SAFETY RECALL NOTICE

Subject: **Motor Vehicle Safety Recall 13V-XXX**
Sportworks APEX 3™ Bicycle Racks

SAFETY RECALL CAMPAIGN #13E- 042

FIGURE 1: APEX REVISION SCHEMATIC

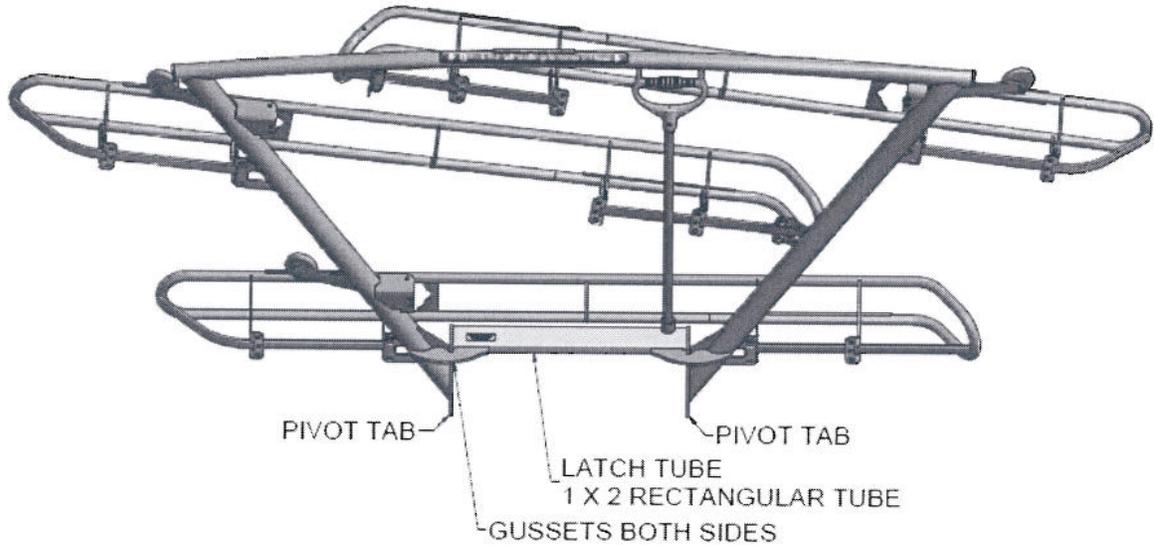
The possibility exists that cracks may develop where the latch tube is welded to the pivot tabs connected to the rack frame.

NOTE: Apex 3™ units manufactured after April 8, 2013 have a larger rectangular tube and gussets supporting the weld between the new latch tube and round frame tubing and are not included in this recall (see Figure 1 attached).

Sportworks will facilitate the replacement of the frame of your recalled Apex 3™ bicycle rack free of charge.

FIGURE 2: APEX RACK INSPECTION

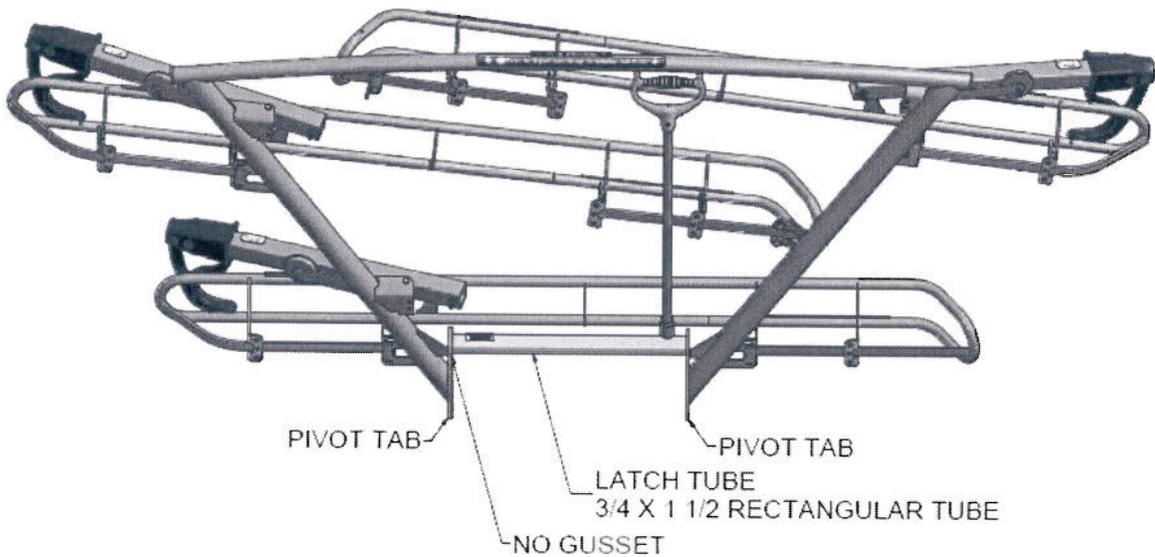
- Inspect rack for cracks that may develop where the rectangular latch tube is welded to the two pivot tabs (see Figure 2 attached).
- If cracks are visible, the Apex 3™ bicycle rack should be removed from the vehicle and not used until the frame is replaced.
- If cracks are not visible, cracks may develop over time and Sportworks highly recommends that the Apex 3™ bicycle rack be removed from the vehicle and not used until the frame is replaced.
